HISTORIC AND DESIGN REVIEW COMMISSION

HDRC CASE NO: 2019-061
ADDRESS: 445 DEVINE ST
LEGAL DESCRIPTION: NCB 2957 BLK 1 LOT 12
ZONING: R-5, H
CITY COUNCIL DIST.: 1
DISTRICT: Lavaca Historic District
APPLICANT: Camden Greenlee
OWNER: Camden Greenlee
TYPE OF WORK: Window replacement
APPLICATION RECEIVED: February 01, 2019
60-DAY REVIEW: April 02, 2019
REQUEST:

The applicant is requesting a Certificate of Appropriateness for approval to replace approximately 18 existing wood windows with new Marvin Infinity brand fiberglass windows in the color Stone White.

STAFF PHOTO - TAKEN 2/13/19

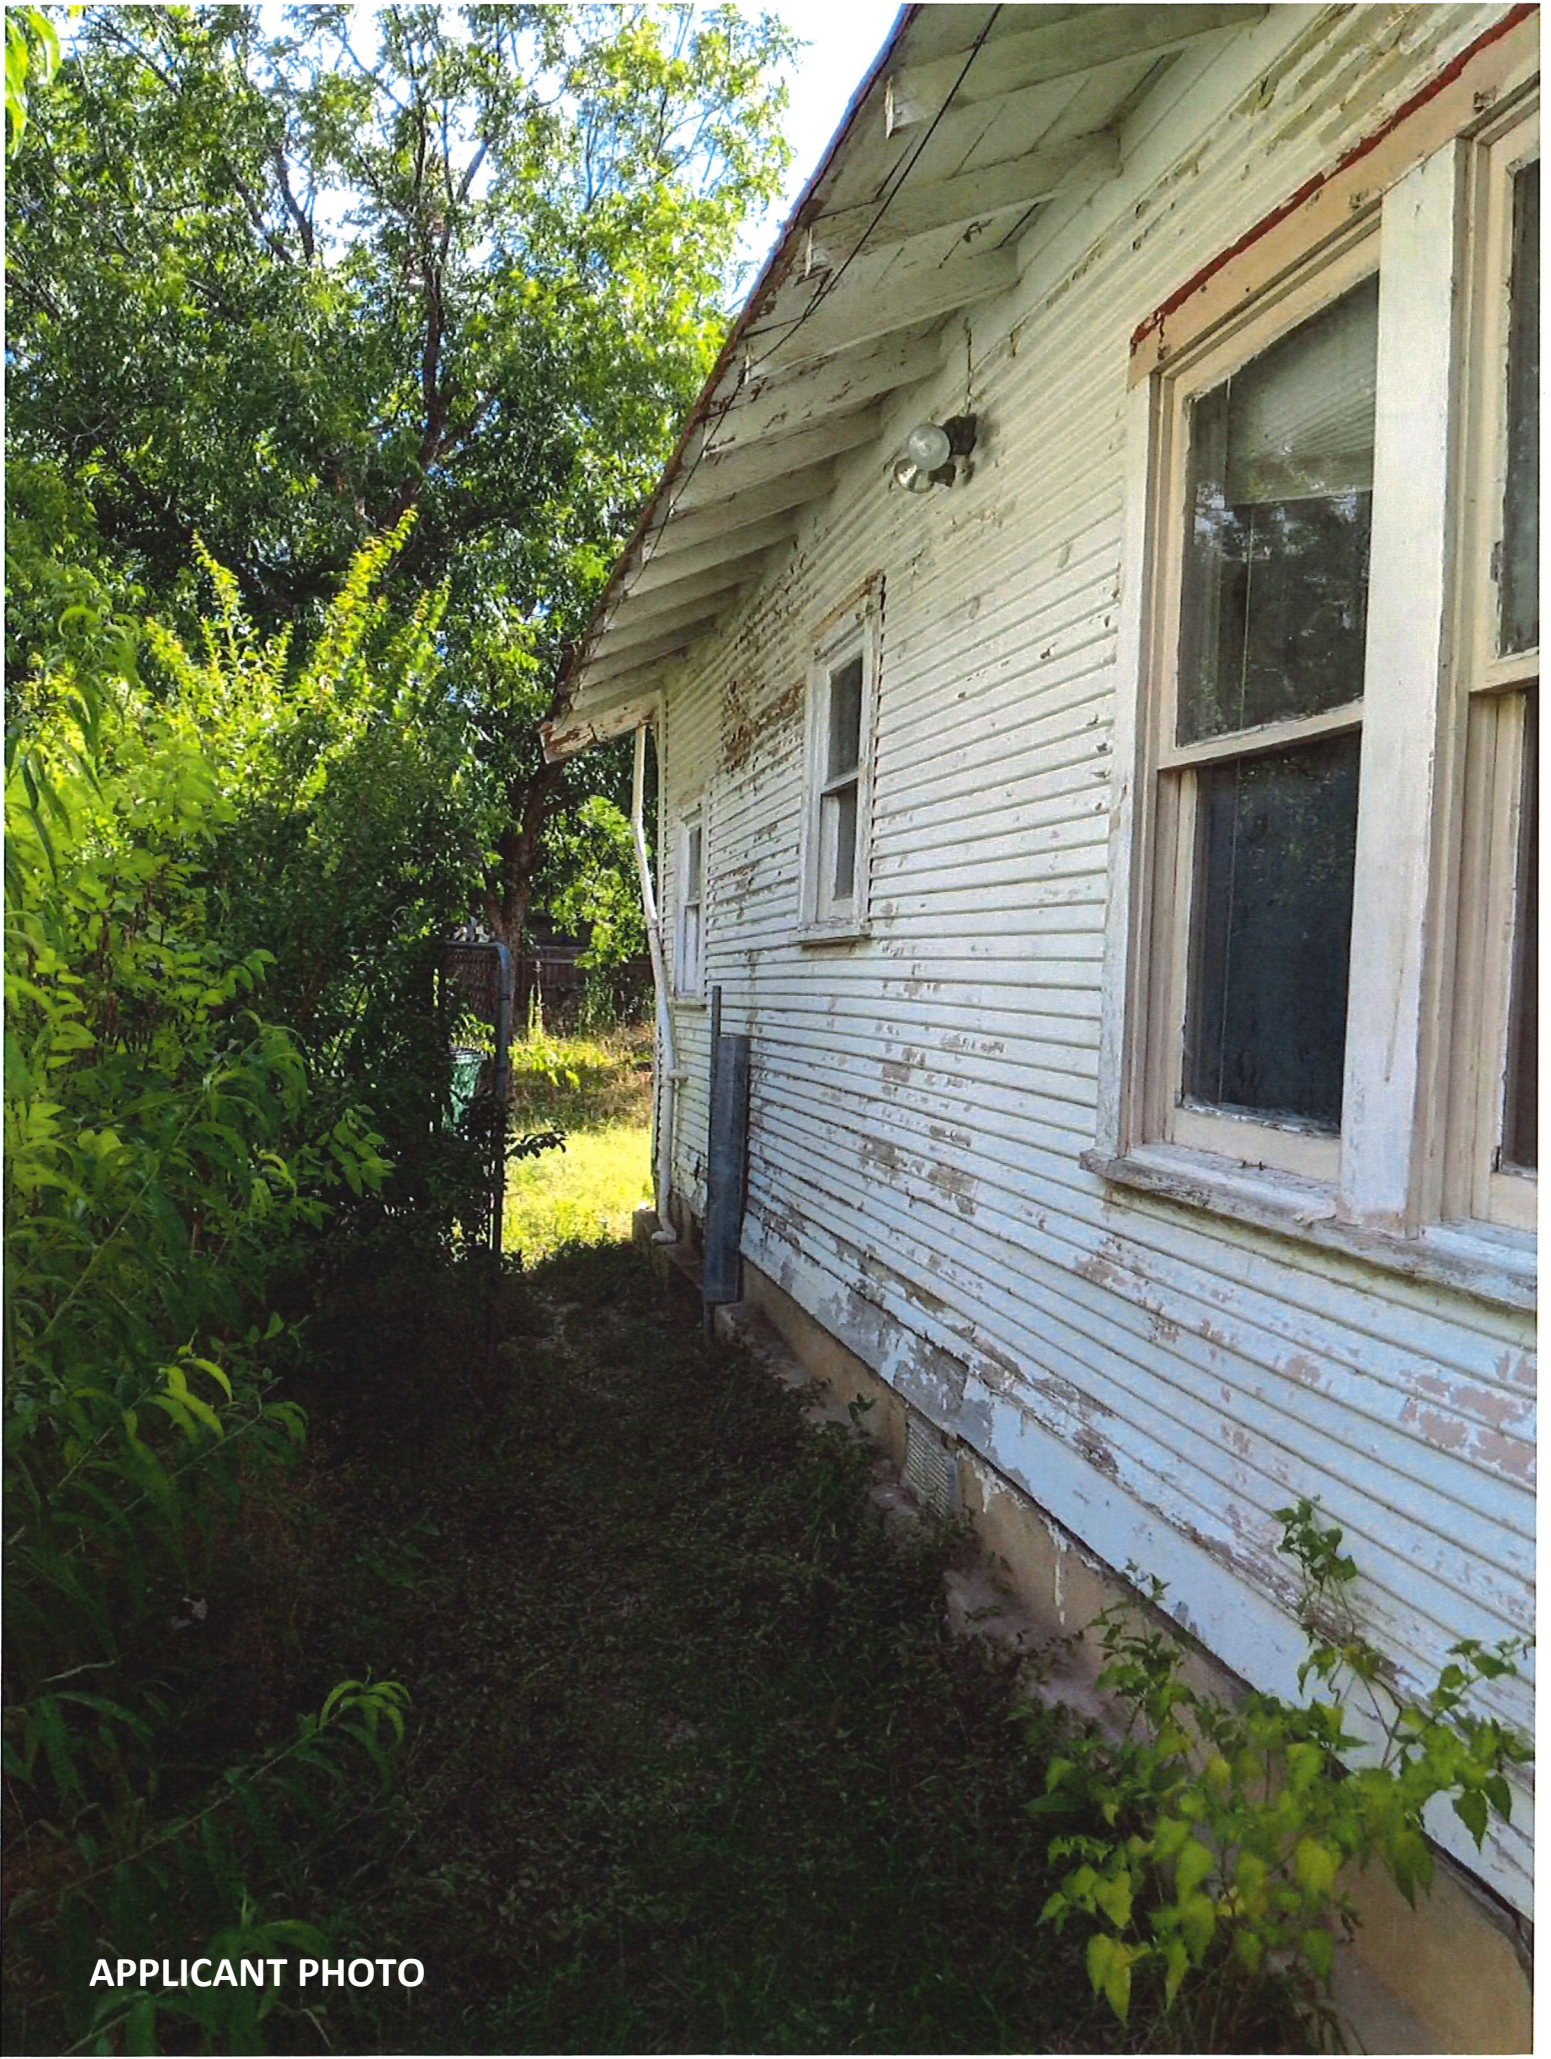
A request for window replacement was submitted by a previous owner and heard by the Historic and Design Review Commission (HDRC) on June 7, 2017. Based on a site visit and photographs, staff noted that the windows were in repairable condition, and the HDRC did not approve the replacement request. Staff conducted a site visit with the current applicant on February 13, 2019, to again examine the condition of the windows. Staff observed that the applicant had removed all weights, pulleys, and interior framing elements, including jambs, stops, and parting beads. The new framing as installed is void of parting beads, interior stops, and other components that allow for operability of historic wood windows. On February 14, 2019,

staff visited the site to place a public notice yard sign and observed the applicant installing the requested new windows prior to receiving a Certificate of Appropriateness.

Staff does not recommend approval of the window replacement based on findings a through c. Staff recommends that the applicant repair the existing wood windows in place.

Head Jamb and Sill
NDH w/ Half Screen

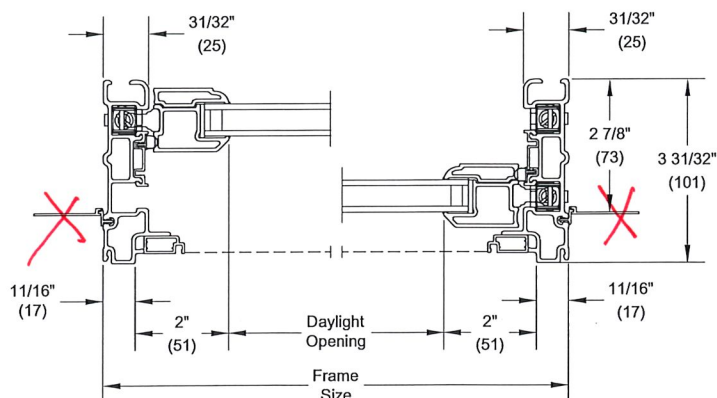
IN ADDITION TO THE APPROVED RENOVATION WORK DATED JULY 17, 2018, I'M
PROPOSING REPLACEMENT WINDOWS (DETAILS ATTACHED). WINDOWS ARE MARVIN
~~INFINITY~~ REPLACEMENT WINDOWS - MEETING AT RAILS IS $1\frac{1}{4}$ ", STILES ARE $1\frac{3}{8}$ " WIDE
(SIMILAR TO EXISTING), COLOR TO BE BENJAMIN MOORE "STONE WHITE" TO MATCH EXTERIOR
TRIM (~~REPLACEMENT~~) PREVIOUSLY APPROVED. ORIGINAL WINDOW STOPS WILL BE
USED TO DETERMINE WINDOW POSITION TO MATCH THE ORIGINAL DEPTH FROM FRONT FACE

(CONTINUED FROM FRONT PAGE) TO FACE OF UPPER SASH. ORIGINAL UPPER SASH IS GREATER THAN 2" FROM FRONT FACE OF TRIM. ORIGINAL WINDOW TRIM WILL BE REFINISHED WHERE POSSIBLE AND REPLACED WITH DIMENSIONALLY IDENTICAL WOOD TRIM WHERE NECESSARY. THE SILL IS SLOPED TO MATCH EXISTING. ALL WINDOW COMPONENTS, INCLUDING TRACKS WILL BE BENJAMIN MOORE "STONE WHITE" TO MATCH ~~THE~~ PREVIOUSLY APPROVED EXTERIOR PAINT COLORS. WINDOWS WILL HAVE NO MUNTINS TO MATCH ORIGINAL.
